CERTIFICATE OF APPROPRIATENESS

RE: Application Number 20-6959; 858 Edison Street, Boston – Edison Historic District

Whitfield Residence– 858 Edison St. Detroit, MI 48206

Written Reply to HDC Questions: (Responses are in blue text)

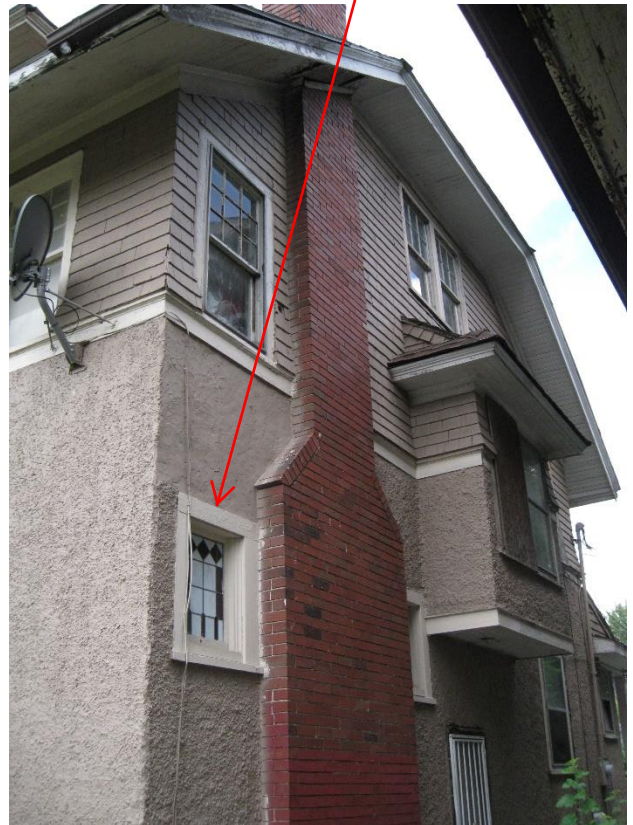
Restore windows,
replace glass, paint

Restore windows,
replace glass, paint

Restore windows,
replace glass, paint

Replace non-
original entry door

Restore windows,
replace glass, paint

Restore 1st floor front windows, replace glass, paint

Restore 1st floor side windows, replace glass, paint

Restore 3rd floor front windows, replace glass, paint

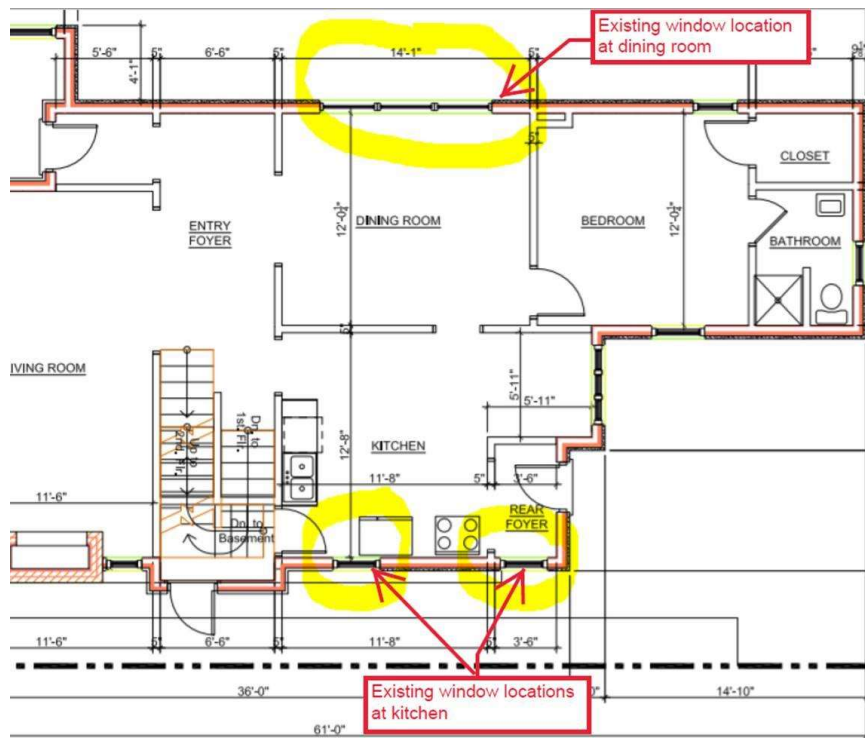
- In the application, you include the B:18 Dark Reddish Brown color as a proposal for the stucco.

- **Is this correct?**

- Reply: Correct the stucco paint color will “Yellowish Grey” same and the windows, and the wood trim.**

1st Floor Existing Drawing

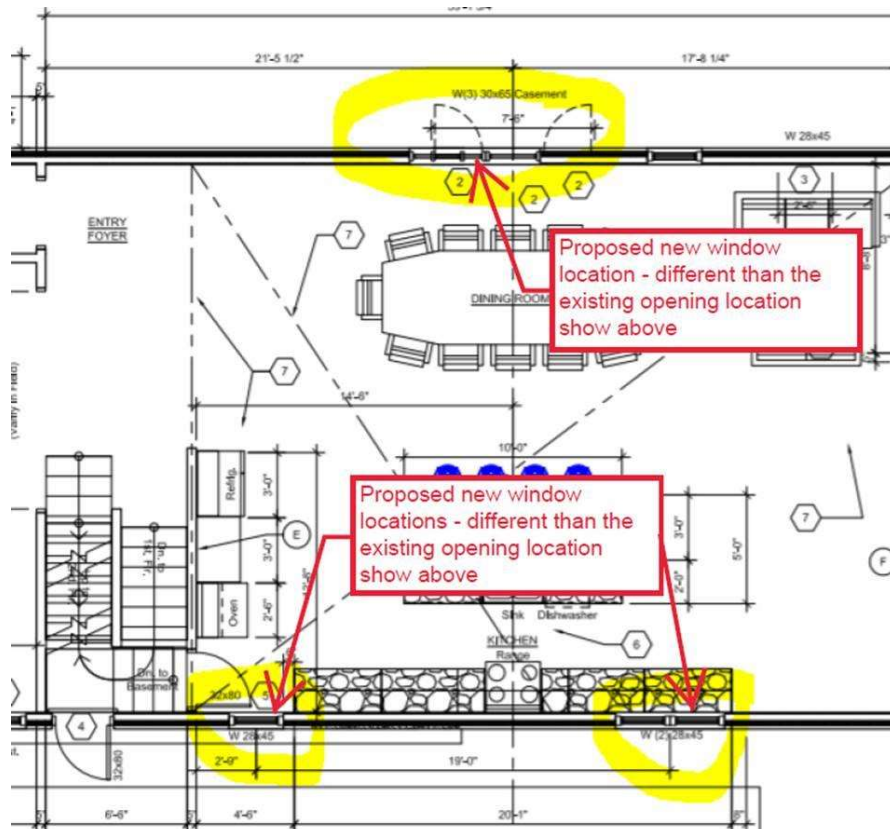
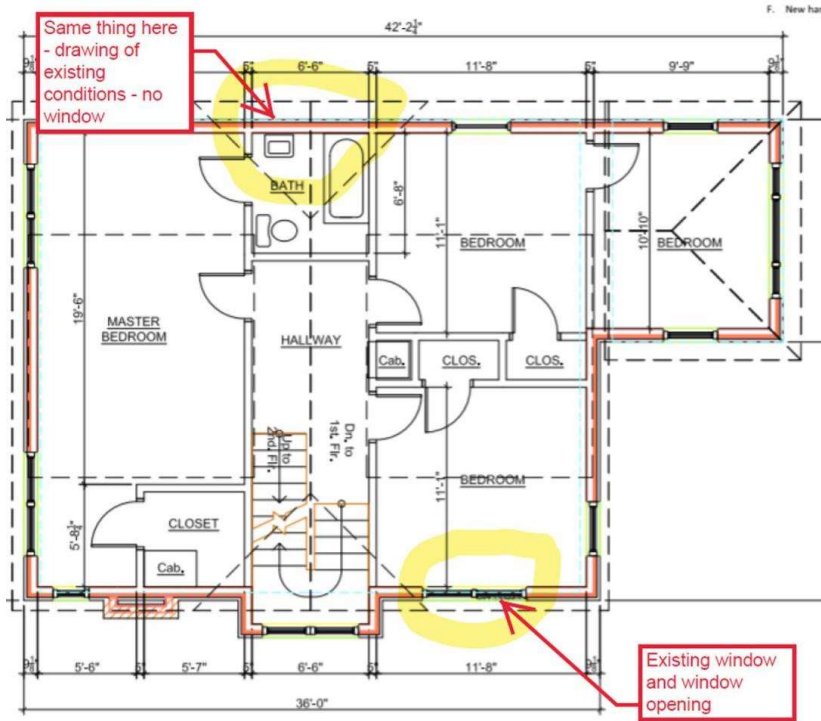
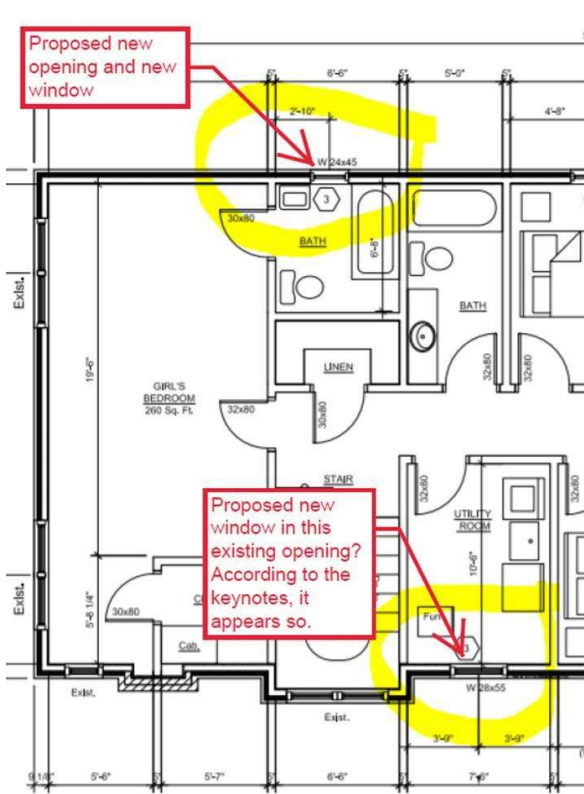
- Your drawings show that you are proposing to completely remove existing windows on the side and rear elevations of the existing house and are proposing to construct new openings (with new windows) in new locations on the side and rear elevations. (See highlighted portions of existing and proposed drawings below for an example)

- Please confirm this is correct.

- Reply: Correct.

Photo of the existing interior & exterior door at the side (east) elevation.

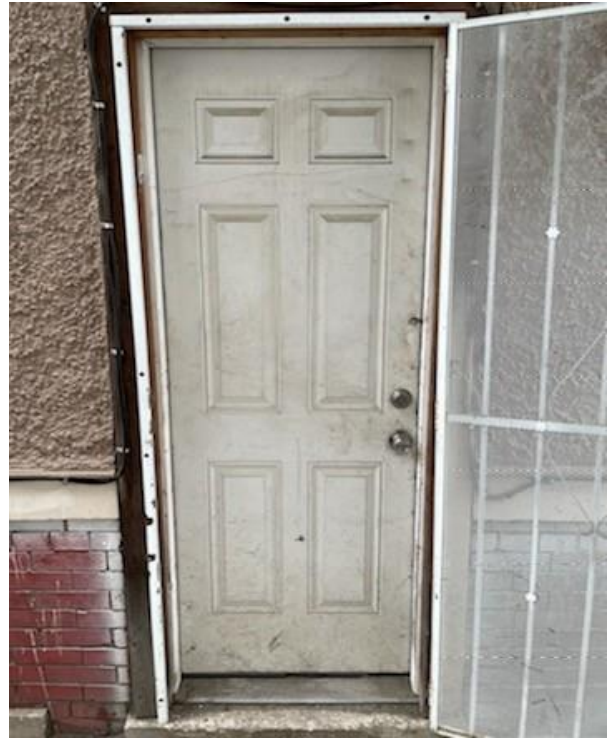
- o **Exterior Door Replacement Proposal** -- You are proposing to replace the two existing doors (1 at the front porch and 1 at the side (east) elevation).

- Reply: A straight on photo is difficult the houses are less than 10' apart.

- Reply: See attached photo.
